# KAMIRA AVENUE VILLAWOOD

RFI - URBAN DESIGN REPORT

JUNE 2023

SITE ANALYSIS

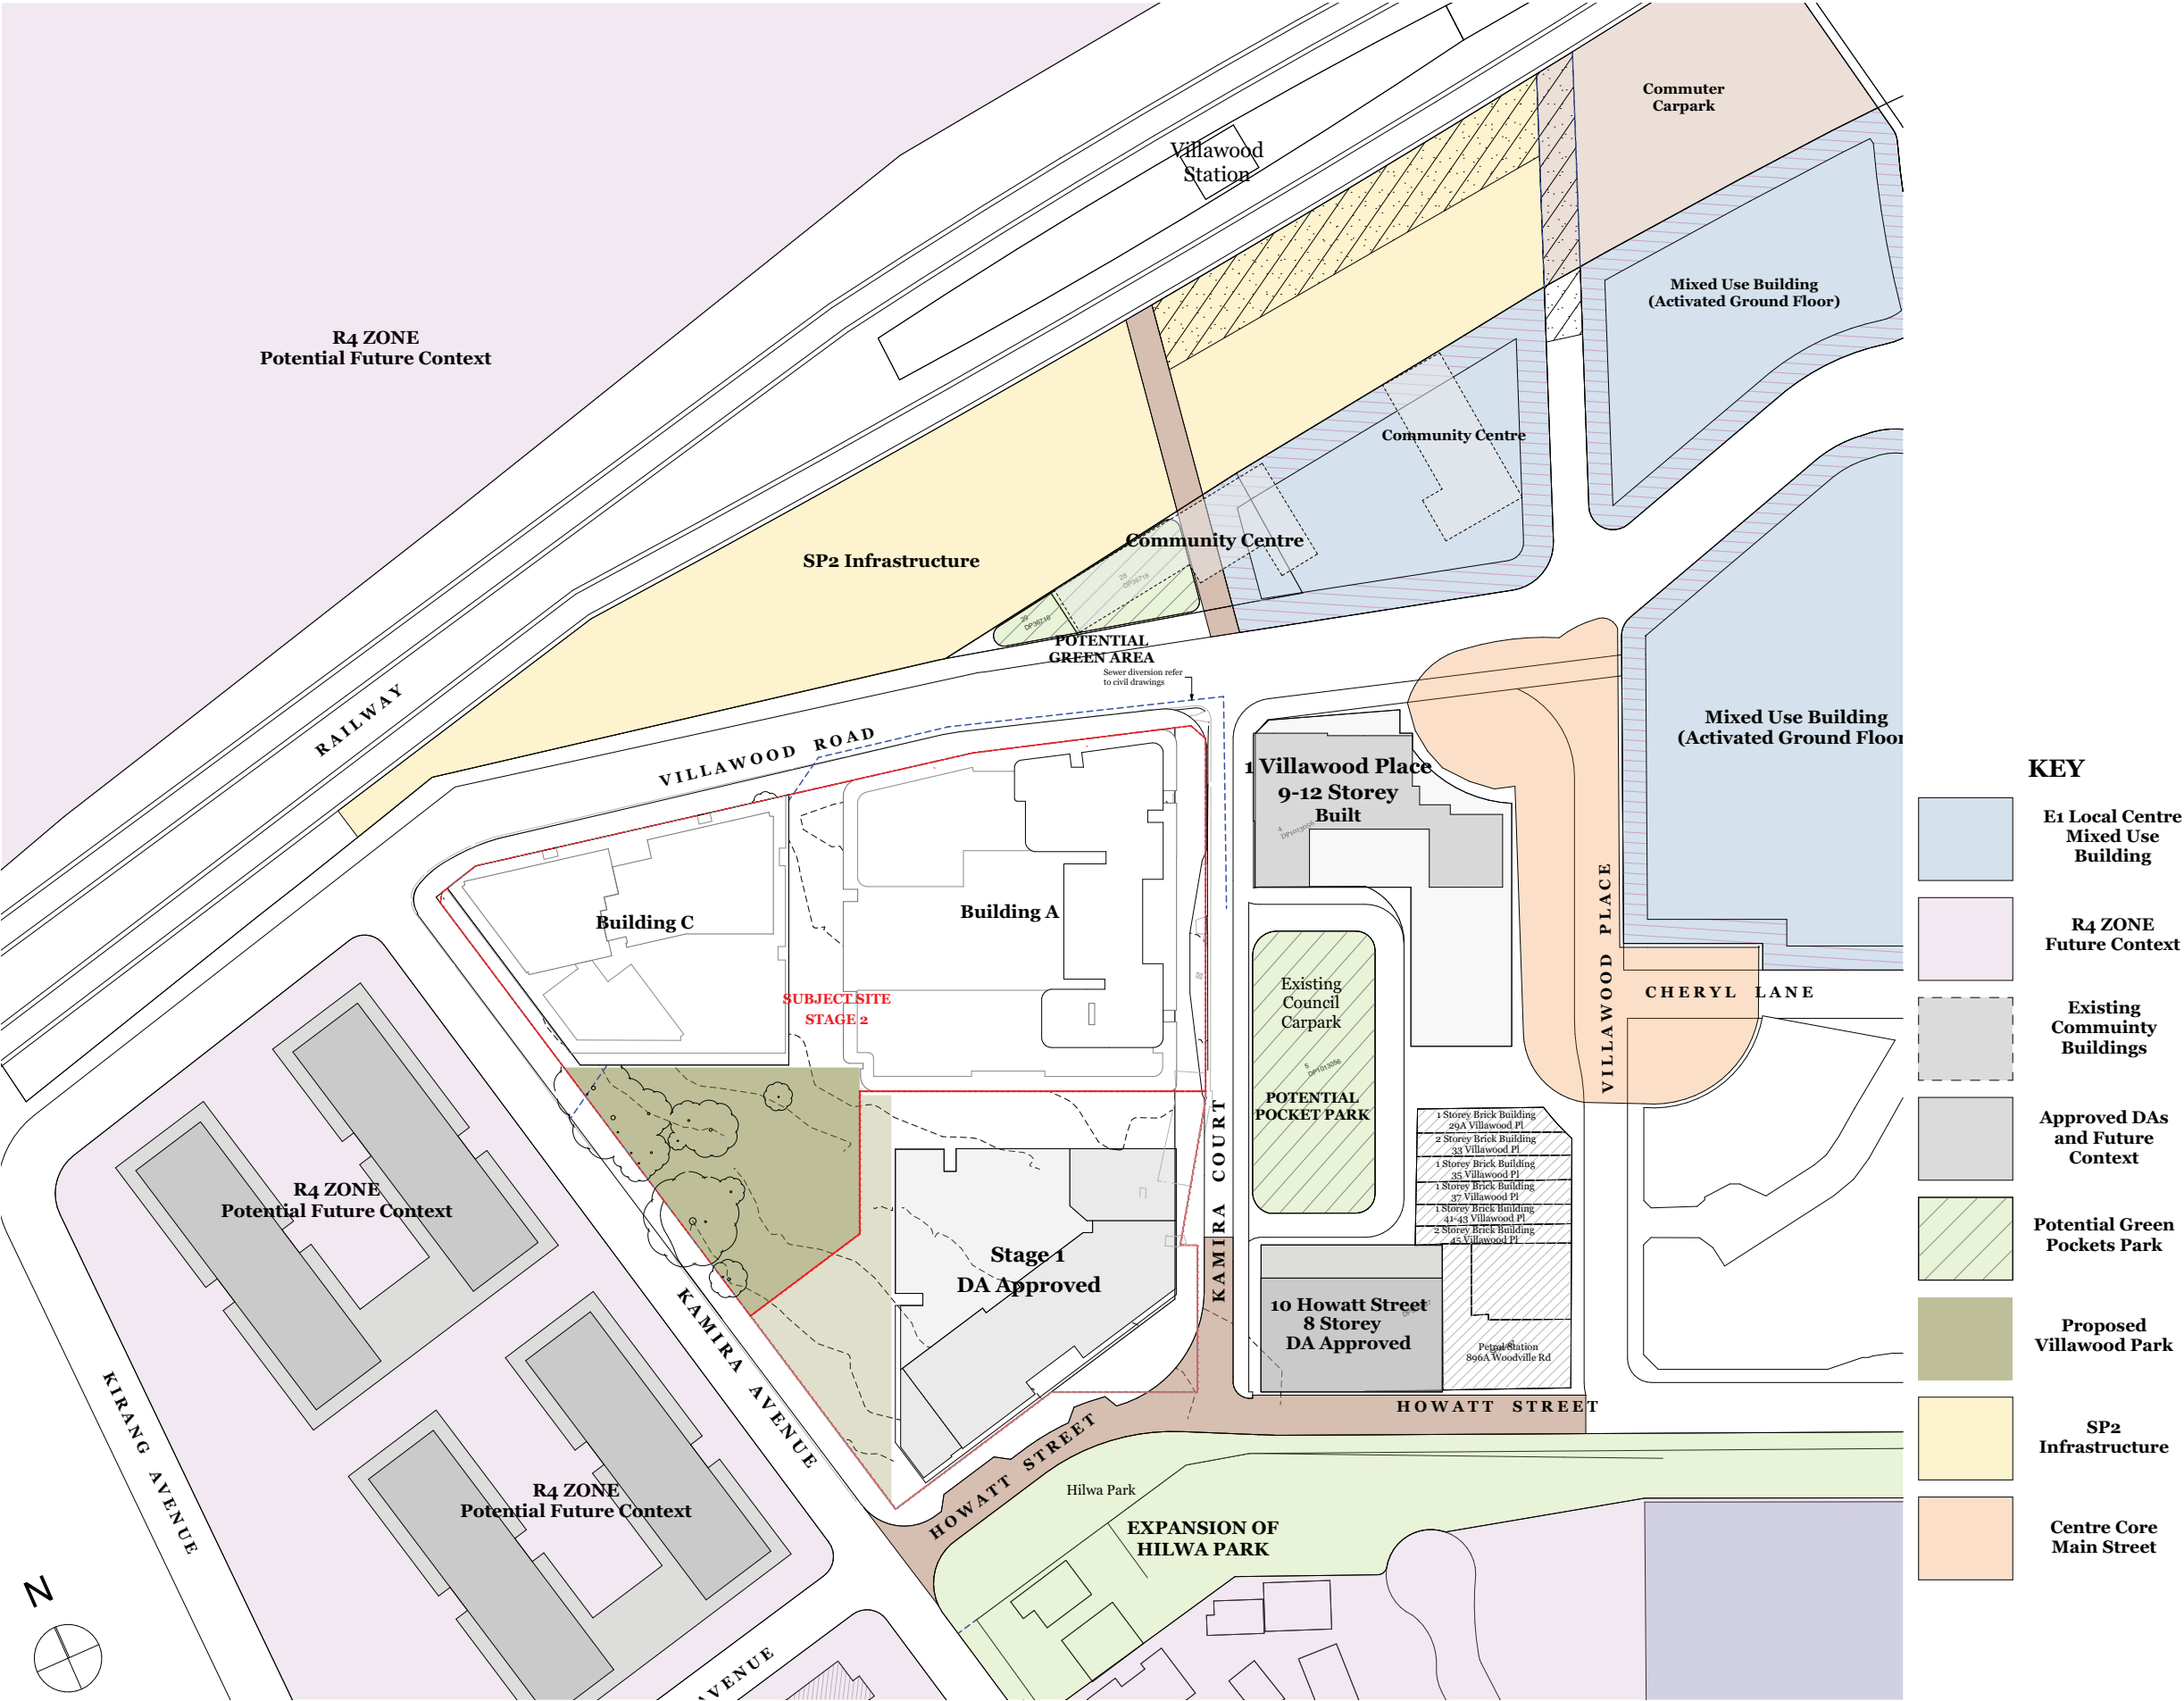
Council Comments

Accordingly, the 3D modelling shall be updated to include a schematic/concept-built form of the R4 residential precincts to the west and south. The current UDR presents these sites as single storey dwellings. It would also be beneficial to understand what is happening north of Villawood Road adjacent the rail line on the mixed-use site to better understand the character of Villawood Road and the gateway when arriving from the west and east.

The site analysis shall be updated to indicate the current Development Applications for adjacent buildings and the potential massing of the R4 sites to west and south.

The analysis plans shall include all public parks and street verges/public domain, major infrastructure such as substations etc in adjacent sites including Hilwa Park to provide a comprehensive analysis of the context of the town centre.

## Shadow Analysis

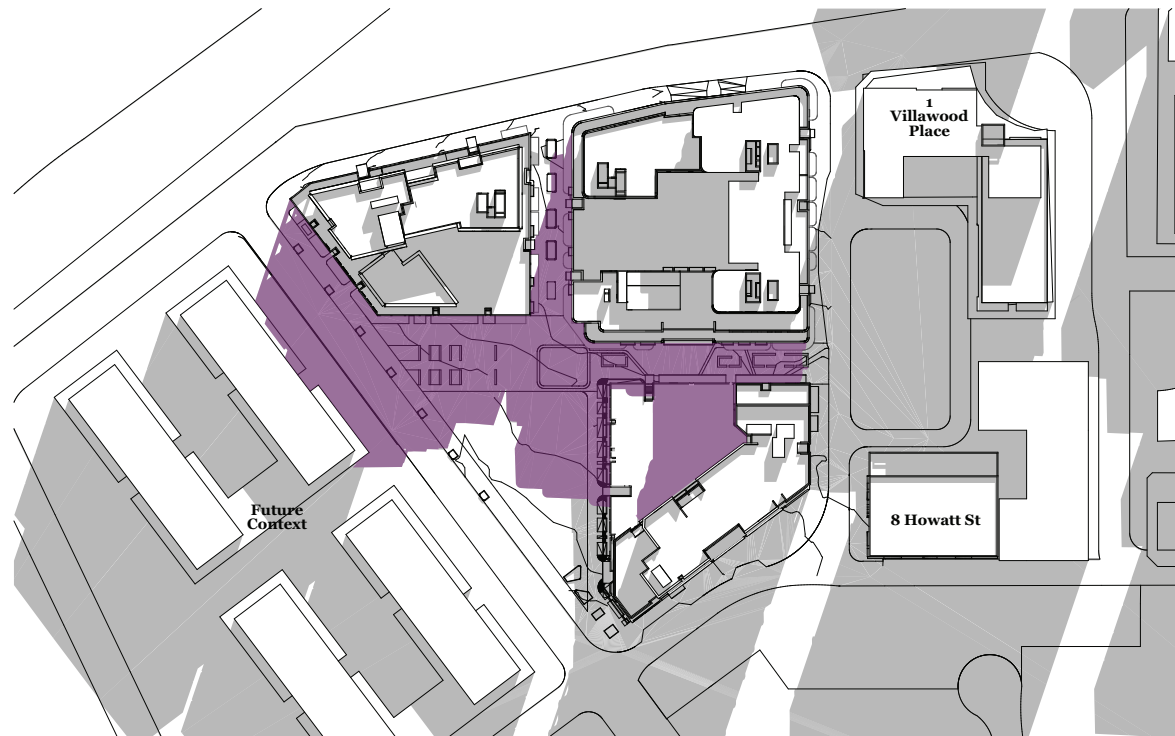
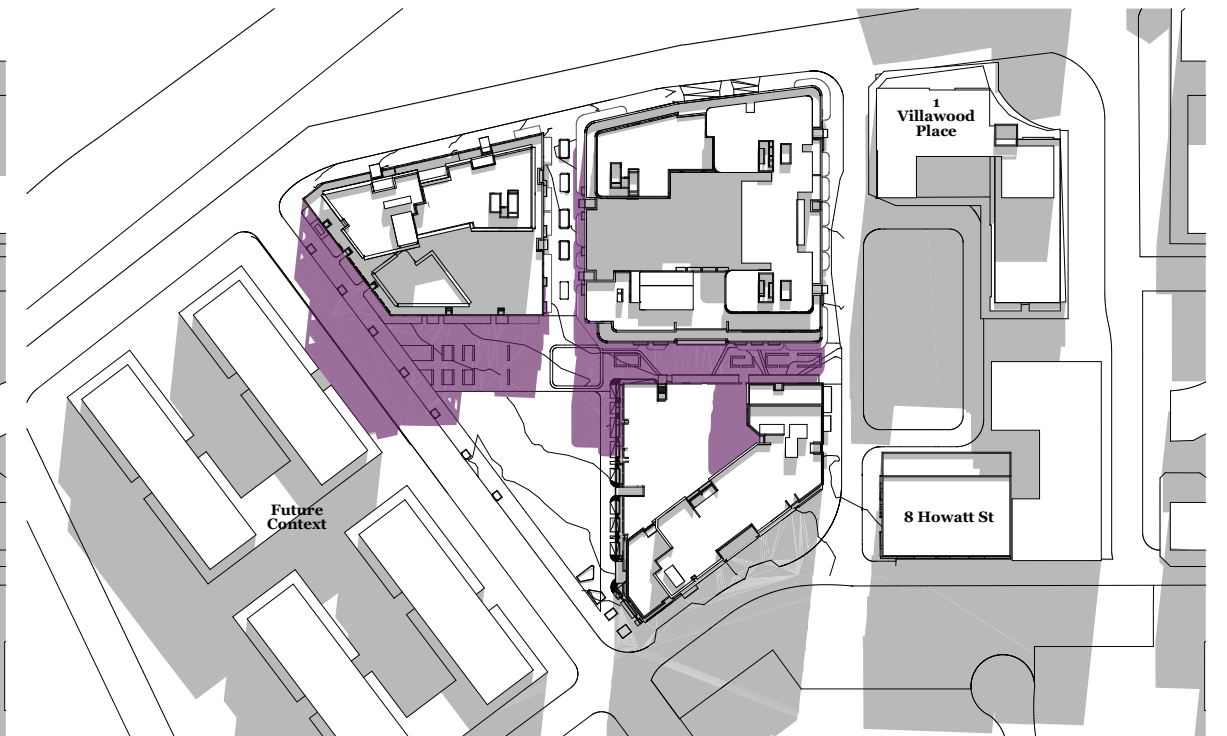
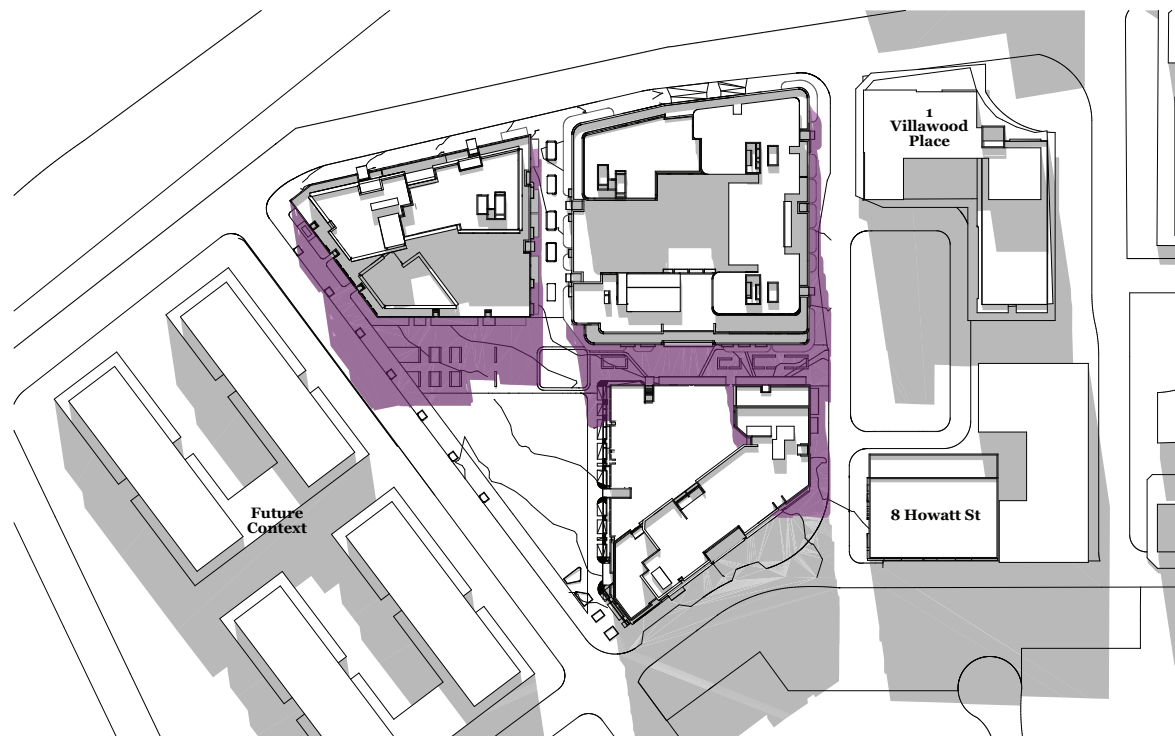
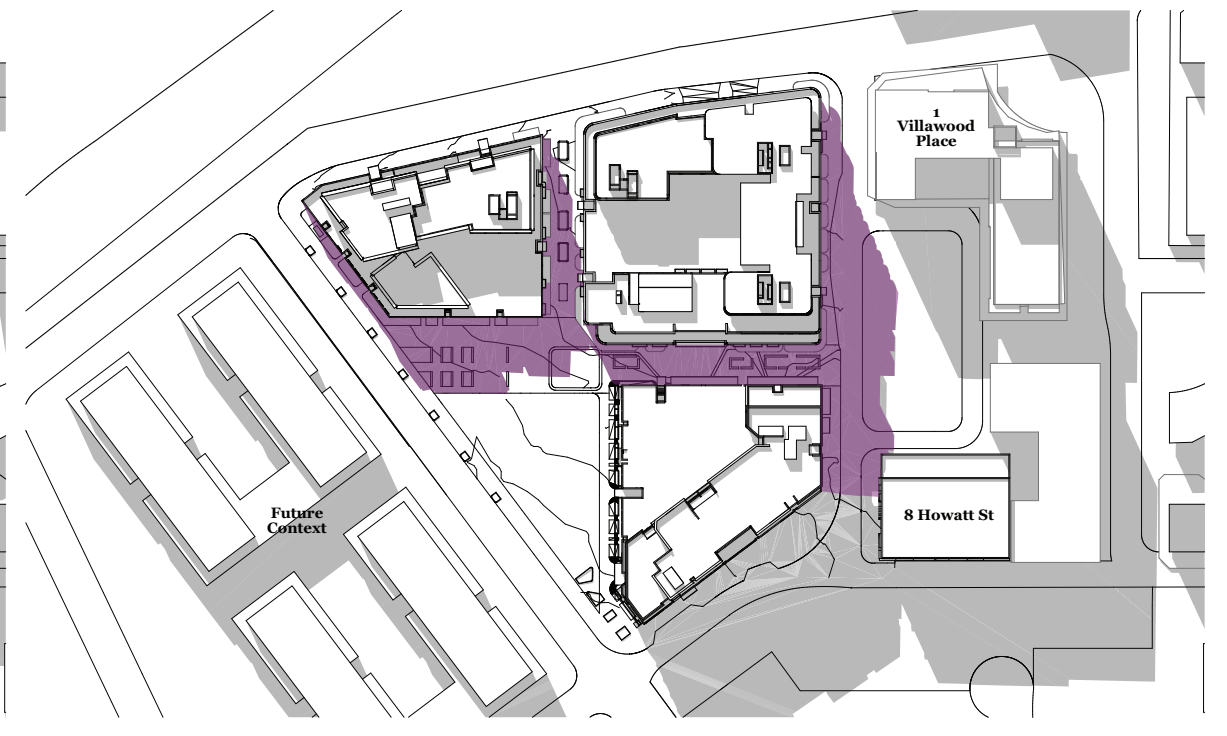
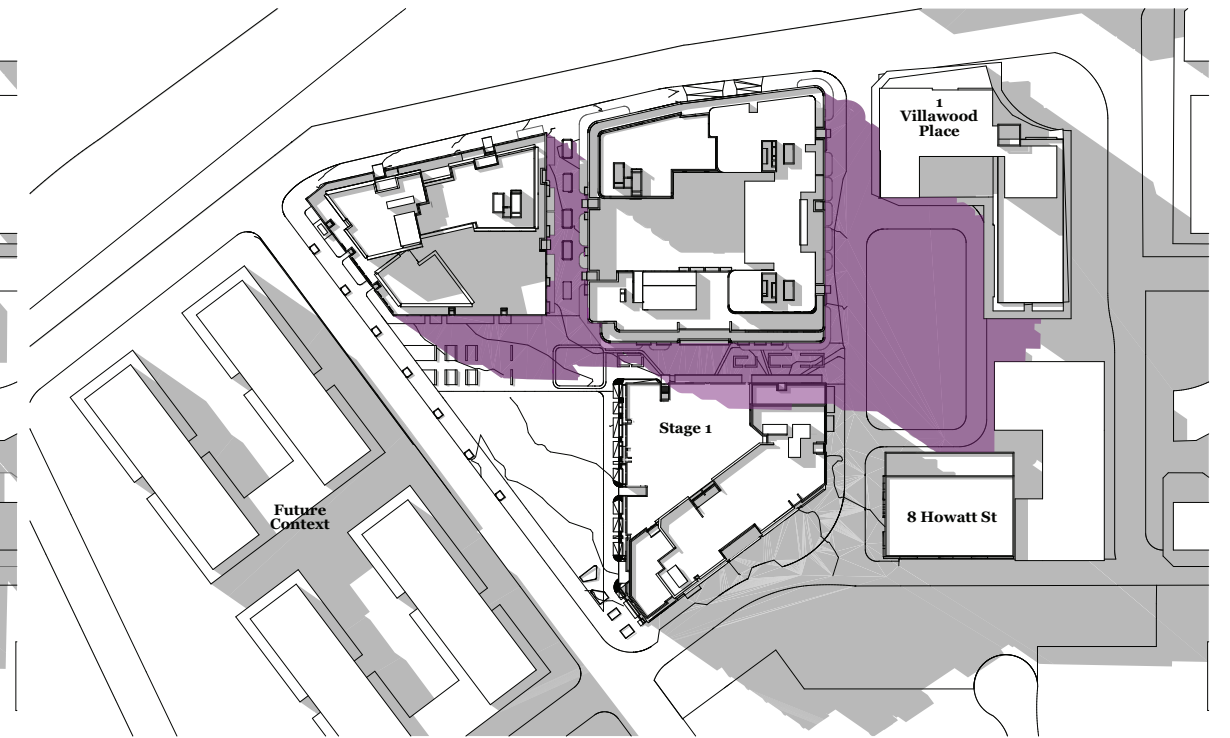
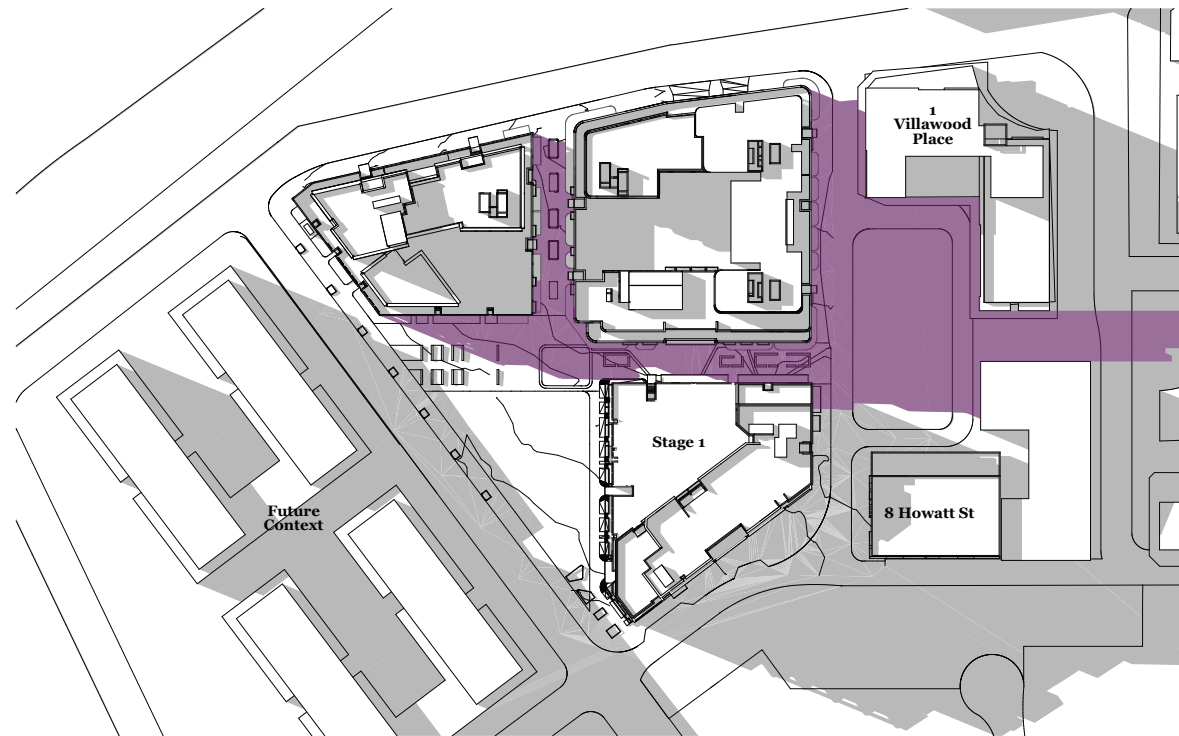
The urban design approach and the solar assessment of Stage 2 must include more detailed description of the impacts on all neighbours including Stage 1 development, as well as existing and approved buildings/DAs on neighbouring properties such as Villawood Place and Pedestrian Mall.

1 Villawood Place  
receives solar from 9am to 1pm

South and West Future R4 Zone  
receives solar from 11am to 3pm

8 Howatt street  
receives solar from 9am to 12pm

Stage 1  
receives solar from 12pm to 3pm

**BUILDING C SOUTH ELEVATION****Council Comments**

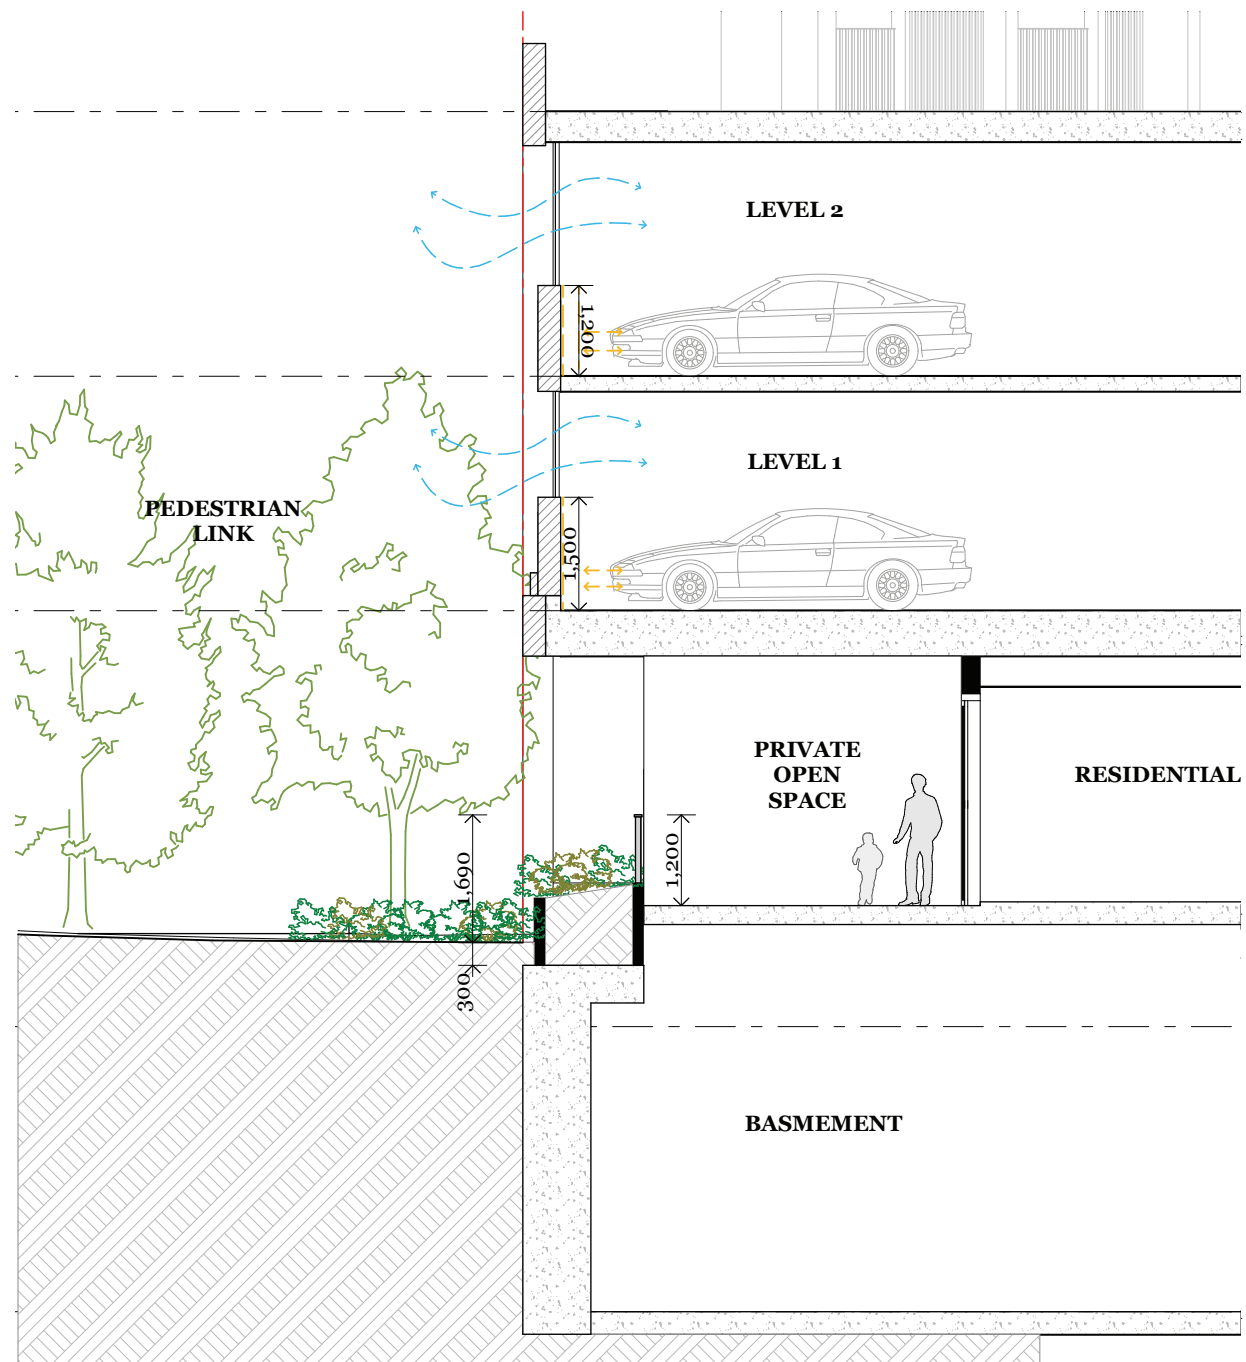
Building C (Western Block) could be improved to incorporate more grounded deep soil central zones to provide more access to light, ventilation and open space.

Remove the podium car park to provide greater landscaped areas, internal courtyard areas and reduce the bulk and scale/visual impacts from the extent of the podiums and add variety to design including definitive corner residential units with well-articulated corner, especially for Block C where the car park is located on south and western elevations.

Building C (Western Block) could allow for deep planting zones with trees surrounded on western and south edge.

Introduction of residential units to the ground level provides with activation to ground and planters that provide visual softening the facade
